From: drainage <drainage@midsussex.gov.uk>
Sent: 31 October 2025 16:23:42 UTC+00:00
To: "Katherine Williams" <Katherine.Williams@midsussex.gov.uk>
Cc: "drainage" <drainage@midsussex.gov.uk>
Subject: 31/10/25 Re: DM/25/0961 - 201 Junction Road Burgess Hill West Sussex RH15
ONX
Attachments: 260825 Proposed Drainage Site Plan.pdf, 070425 Indicative Surface and Foul Water Drainage Proposal 0428.PL.302 rev A.pdf, 220425 Network Rail.pdf
Importance: High

- Proposed Foul and Storm Water Drainage - DWG No & Rev: 100 P4
- Drainage Details - DWG No 7 Rev 201 P3
- Soakaway Calculations - dated Aug 2025 by Simon Dent Associates
- Infiltration Testing Summary - dated 10th October 2025 by Simon Dent Associates

07/04/2025 - Indicative Surface and Foul Water Drainage Proposal 0428.PL.302 rev A was submitted. A soakaway was proposed >20m's away from Networks rails boundary (red arrow)

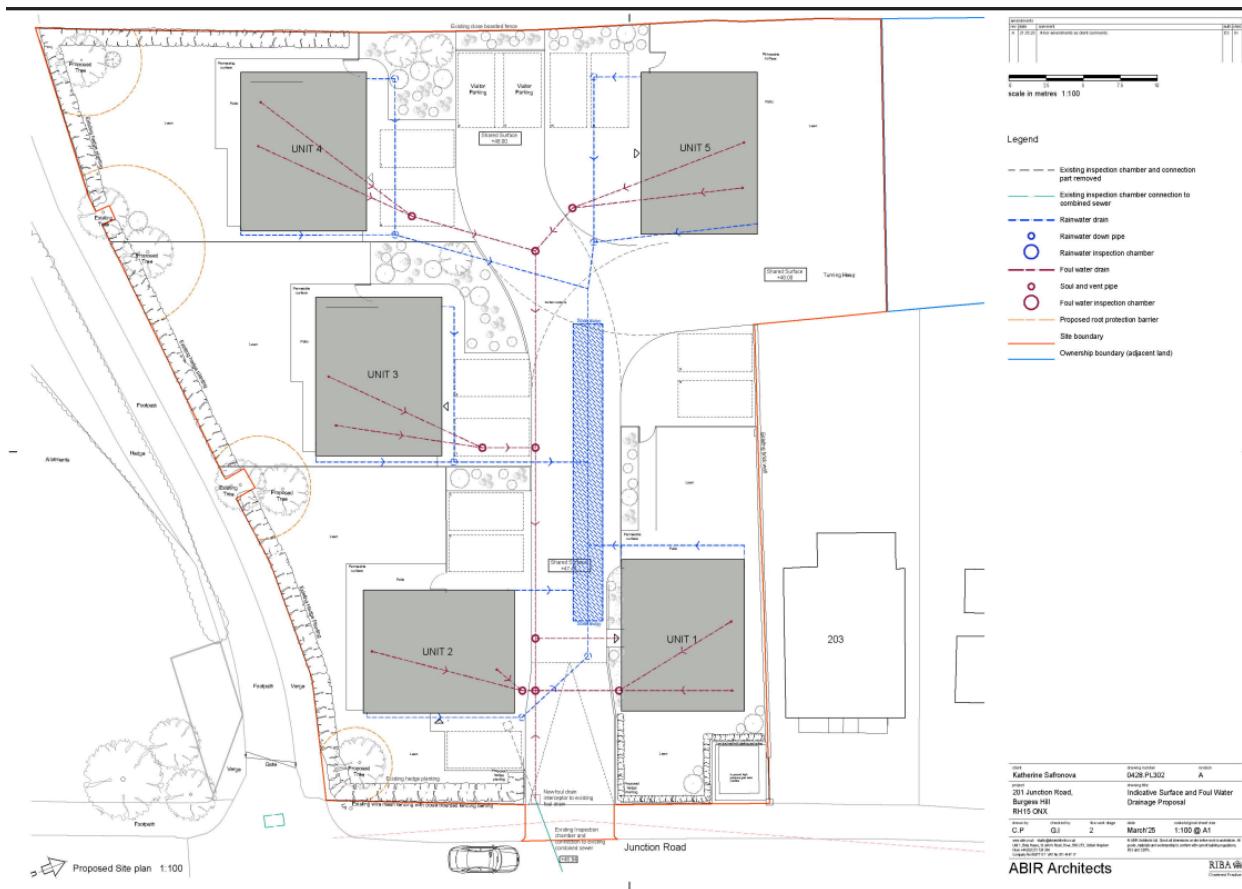
Network Rail should be reconsulted at this stage of the application, based on the design changes submitted.

While the applicant has demonstrated to the Flood Risk and Drainage Team with the latest drainage plan (26/08/25) that the site can be drained it does not comply to Network Rail Asset Protection requirements, therefore upon reconsult the applicant will need to redesign their strategy. All the key documents attached.
